PRELIMINARY SITE PLANS FOR  
**ROCHESTER RETAIL**  
 N.E.C. OF ROCHESTER ROAD AND AVON ROAD  
 CITY OF ROCHESTER HILLS, OAKLAND COUNTY, MICHIGAN

Conditions and mark-ups noted throughout the plan set must be addressed prior to final approval.

REVISIONS	
CITY COMMENTS	6/16/21
CITY COMMENTS	7/21/21

**COVER**

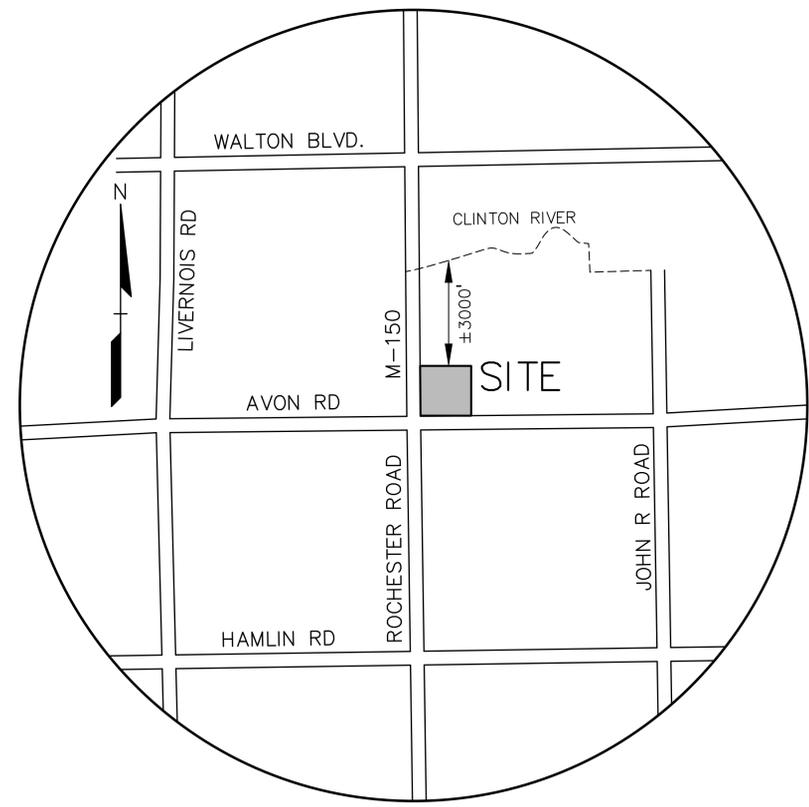
**NOTE:**  
 A CONDITIONAL USE PERMIT IS  
 REQUIRED FOR THE DRIVE-THROUGH

Refer to Section 138-1.203 of the Zoning Ordinance for conditional use signage requirements. Signs advertising a conditional use is proposed for the property must be posted 15 days prior to the public hearing.

DRAWING NUMBER:  
**C-3.0**

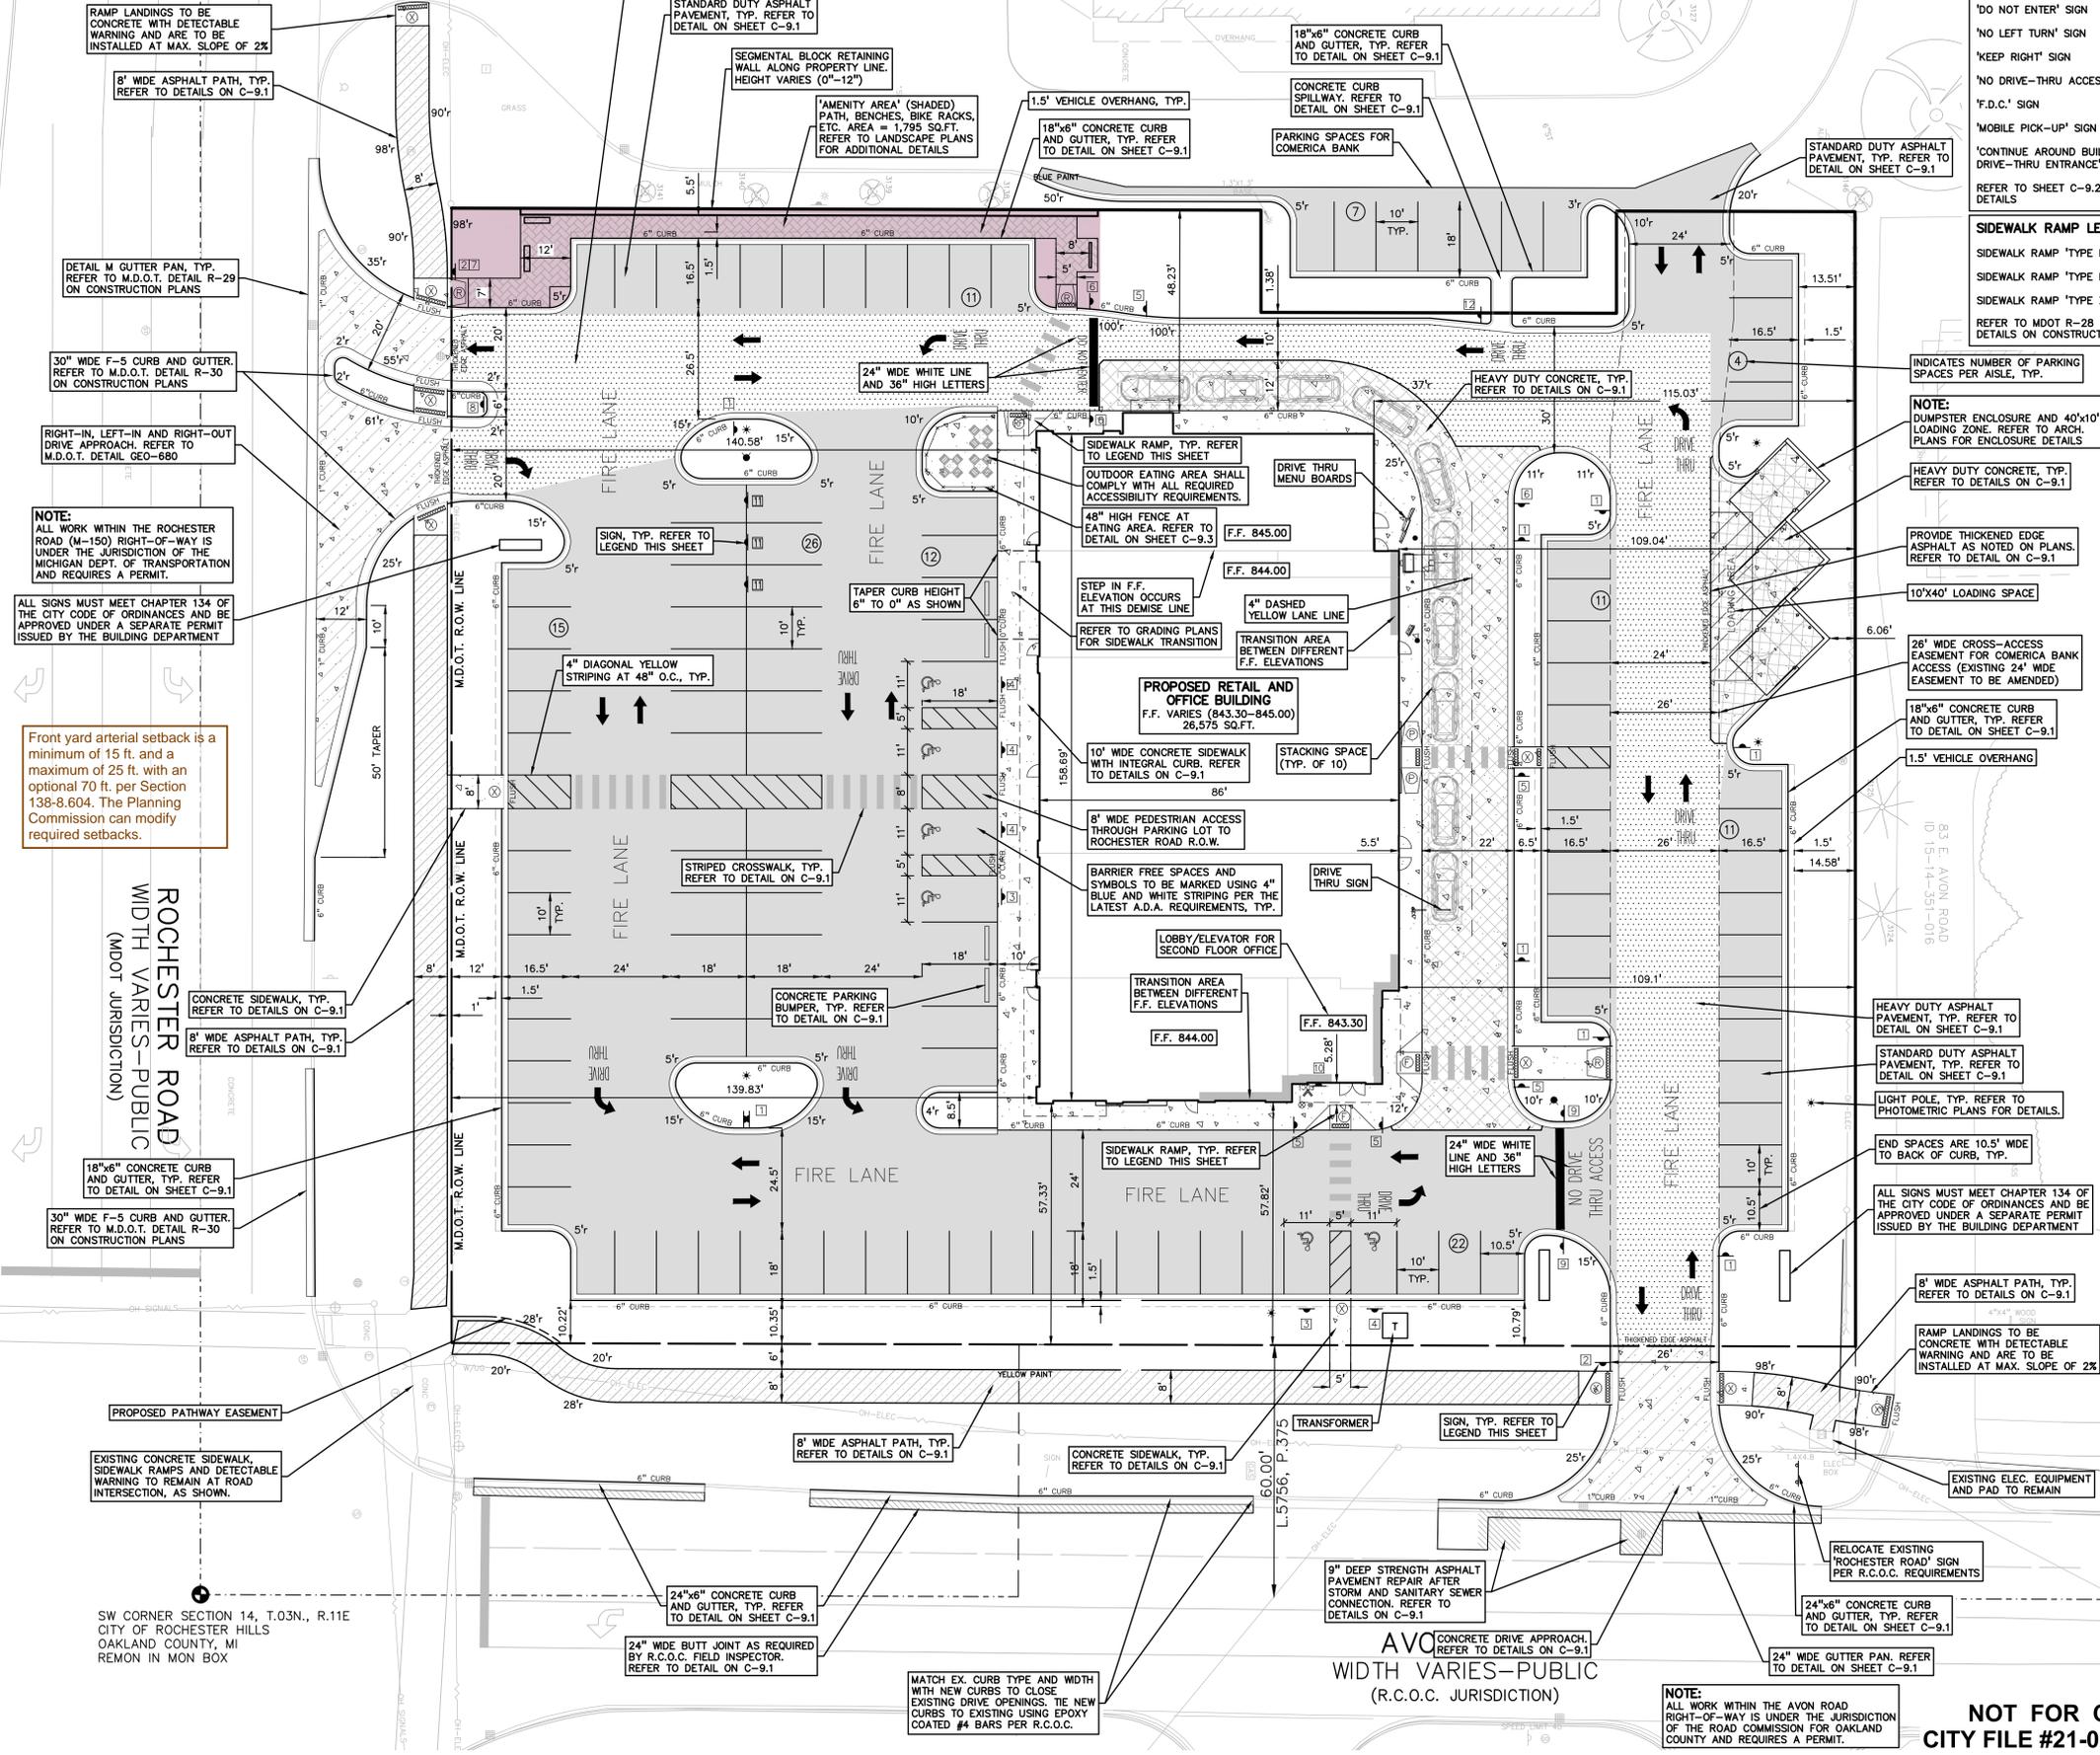
Front yard arterial setback is a minimum of 15 ft. and a maximum of 25 ft. with an optional 70 ft. per Section 138-8.604. The Planning Commission can modify required setbacks.

**C-6.2**

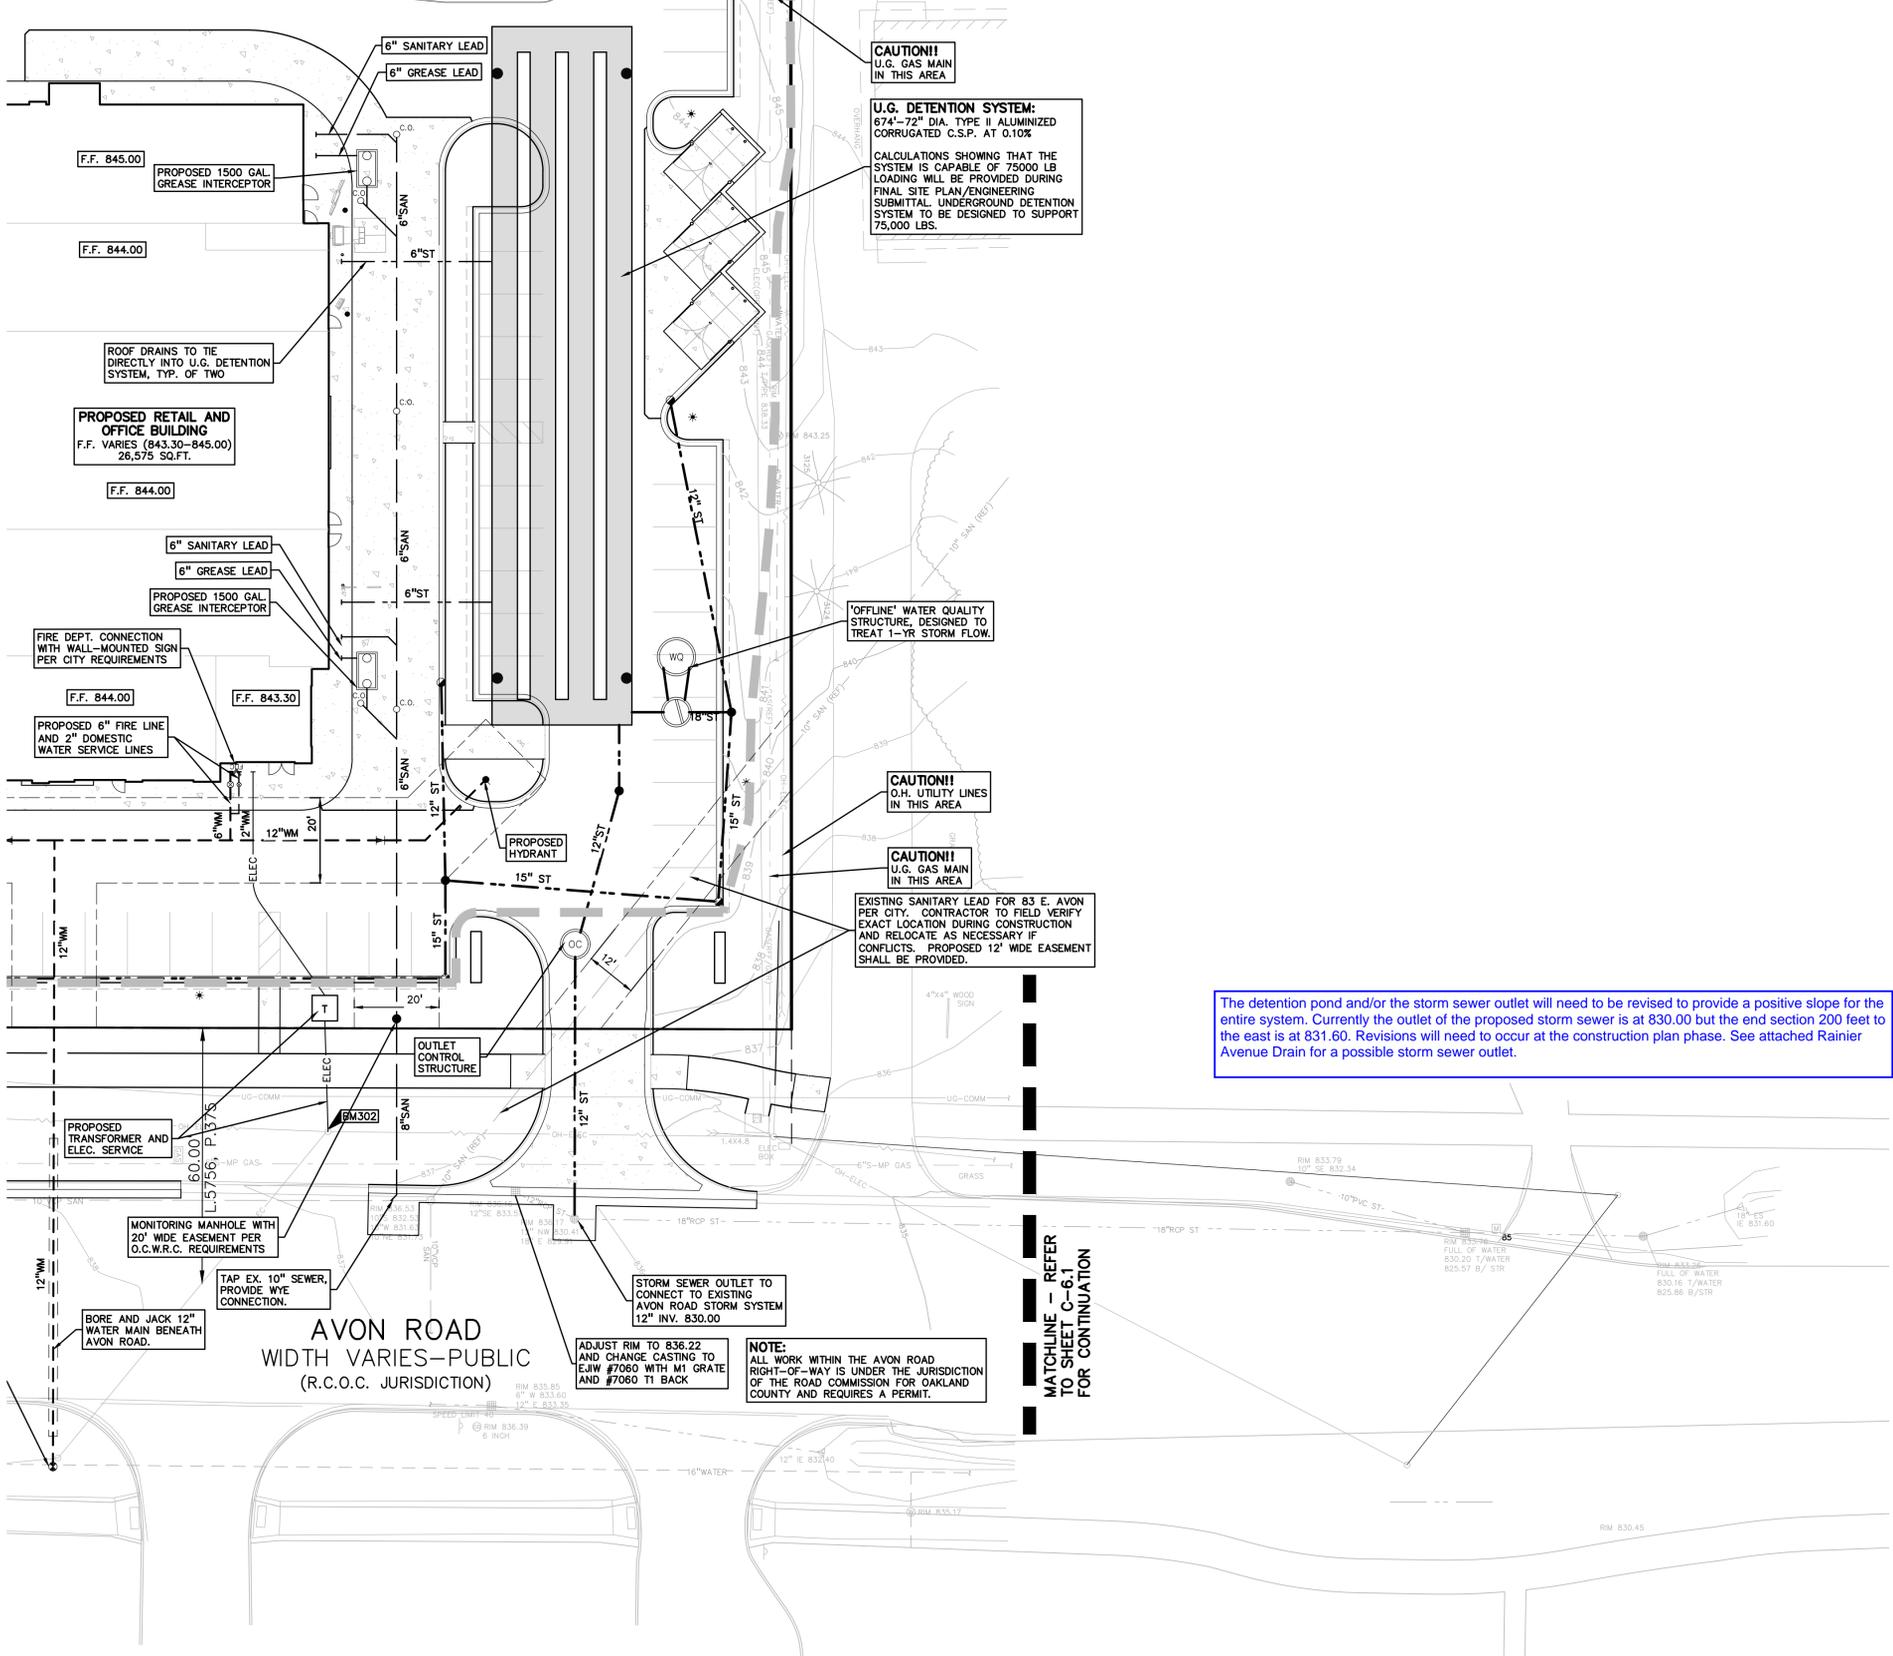
The detention pond and/or the storm sewer outlet will need to be revised to provide a positive slope for the entire system. Currently the outlet of the proposed storm sewer is at 830.00 but the end section 200 feet to the east is at 831.60. Revisions will need to occur at the construction plan phase. See attached Rainier Avenue Drain for a possible storm sewer outlet.

**L-1.0**

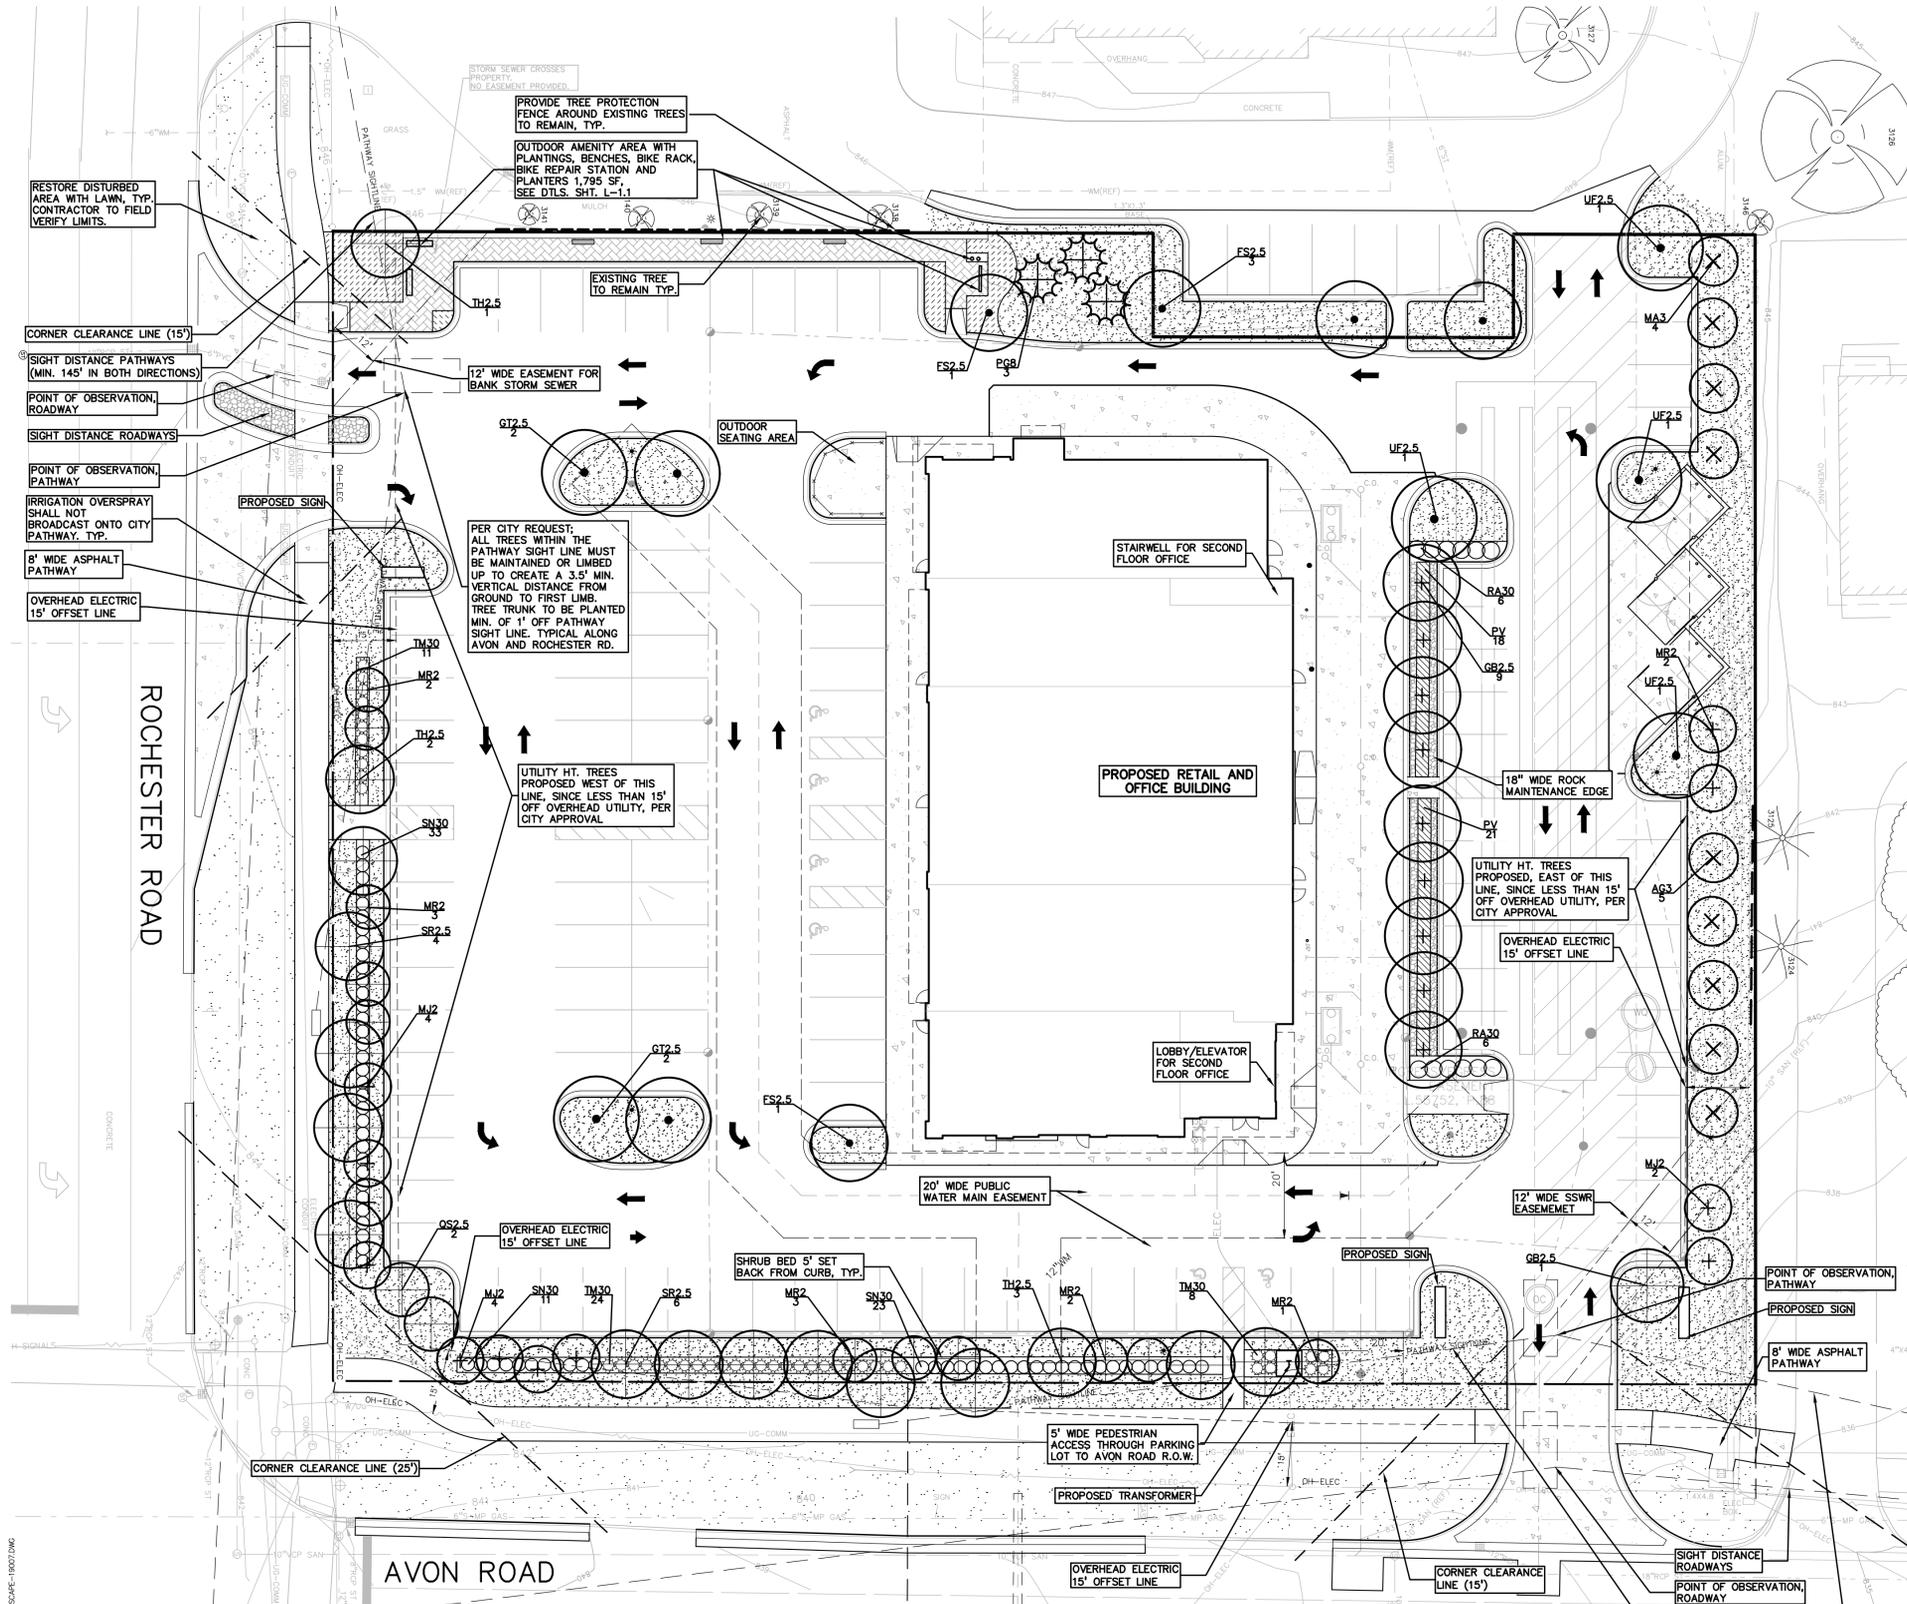
Add note: Irrigation overspray shall not broadcast onto the City pathway.
